**RE: Response to Chick-fil-A Rochester Hills Comments – TIS**

Fleis & Vandenberg (F&V) staff has completed this letter in response to comments provided by Hubbell, Roth & Clark, Inc. in a review letter dated November 9, 2022, and by MDOT provided on November 20, 2022, regarding their review of the F&V Traffic Impact Study dated October 19, 2022. Additionally, F&V held hybrid meeting to discuss the review comments with MDOT, the City of Rochester Hills, and the City's traffic consultant (HRC) on November 21, 2022. The comments related to the traffic study and site plan provided by HRC and MDOT, and the corresponding F&V and Stonefield responses are summarized herein.

**FIGURE 2**  
**LANE USE AND TRAFFIC CONTROL**

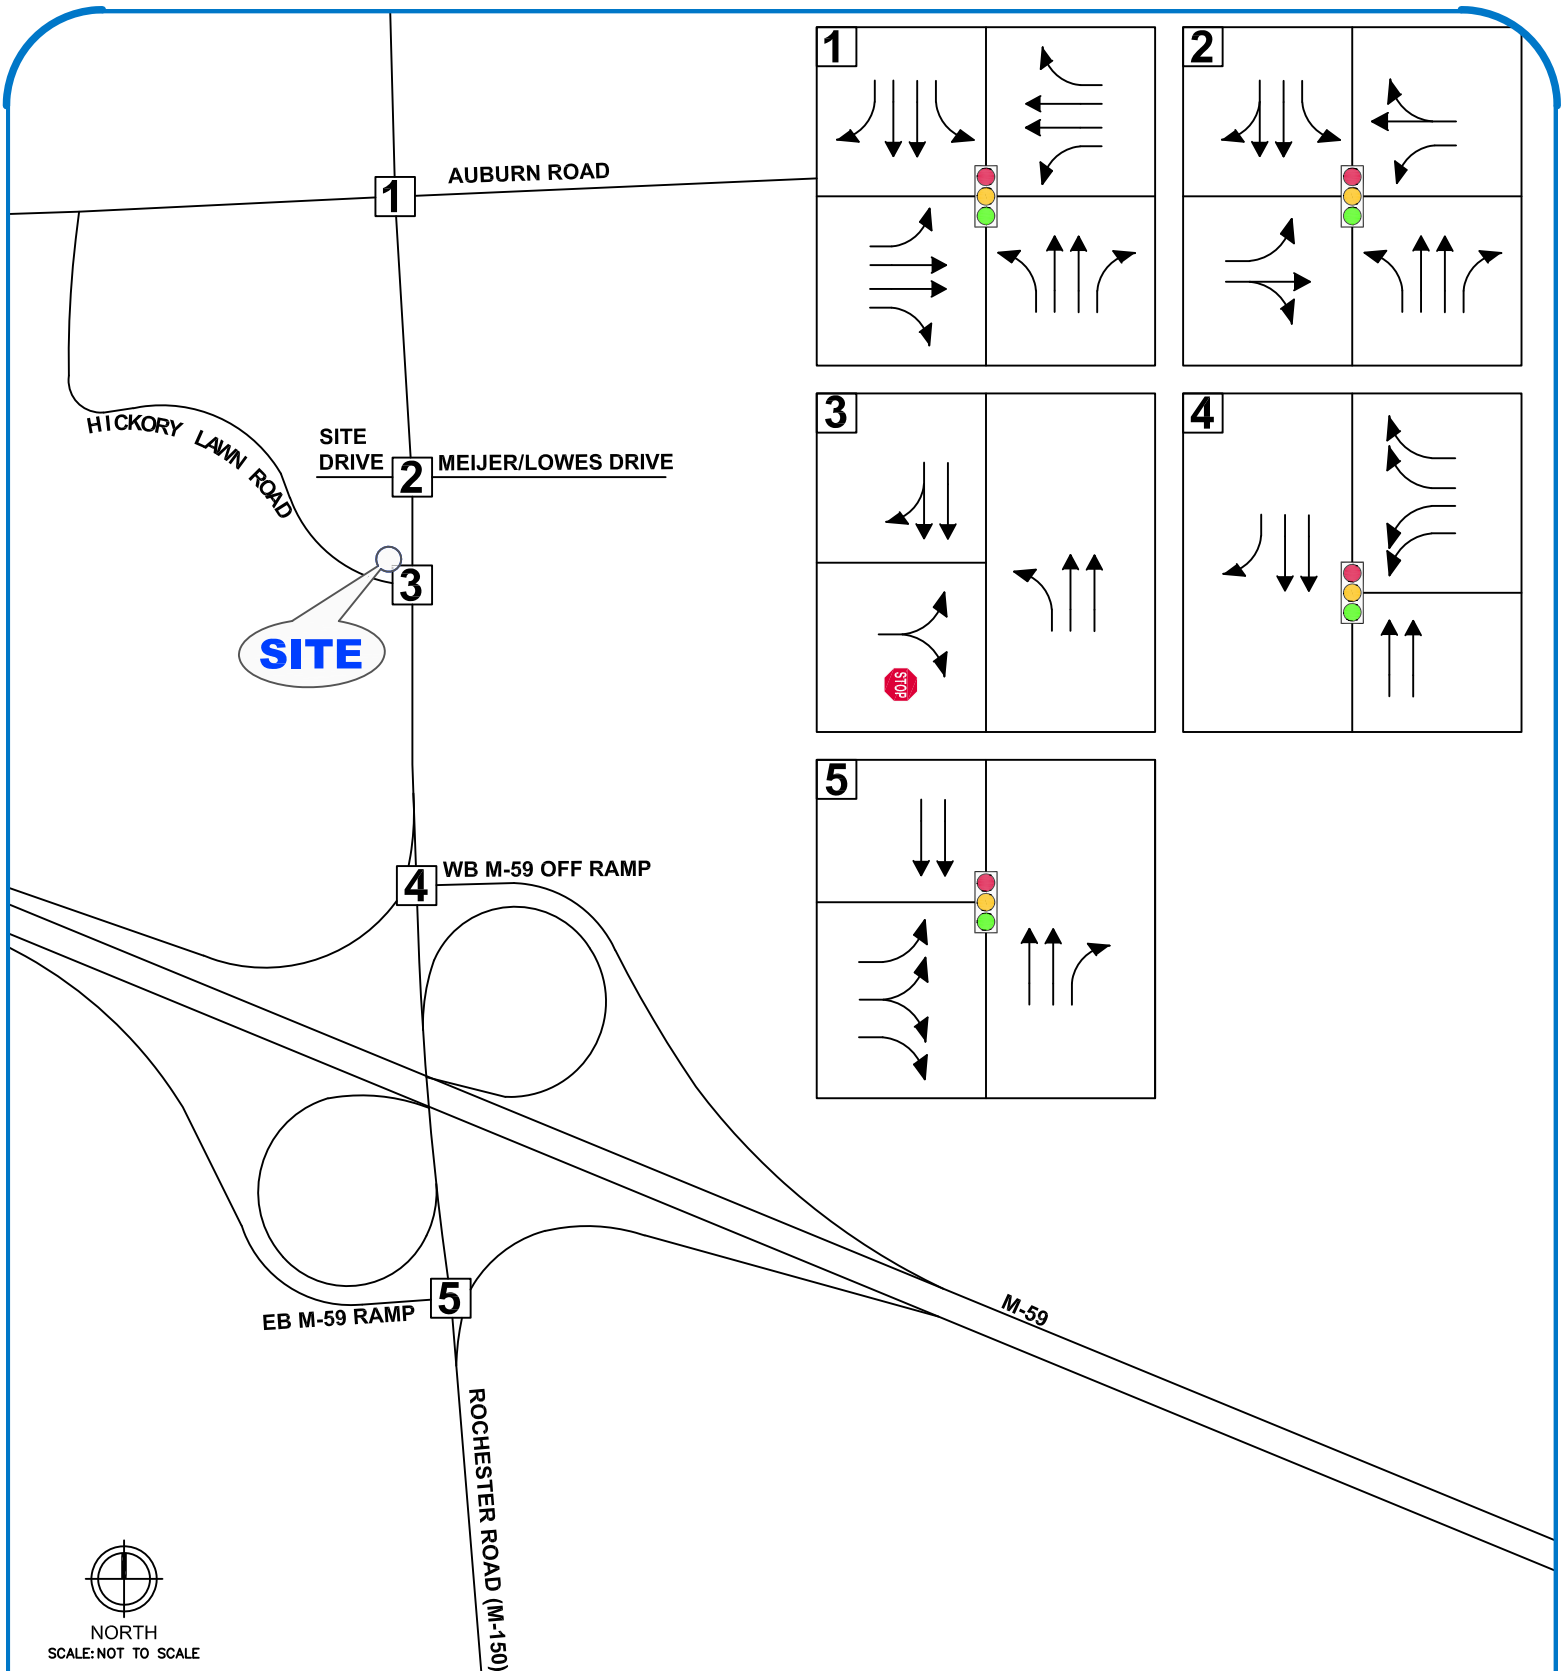
***HRC Comment #3: Background Data: Figure 2 shows the intersection of Rochester Road and the Site/Lowe's Driveway as being a two-way stop control, but the traffic control is signalized. Figure 2 should be updated to show the correct traffic control.***

**F&V Response:** Noted, revised Figure 2 attached.
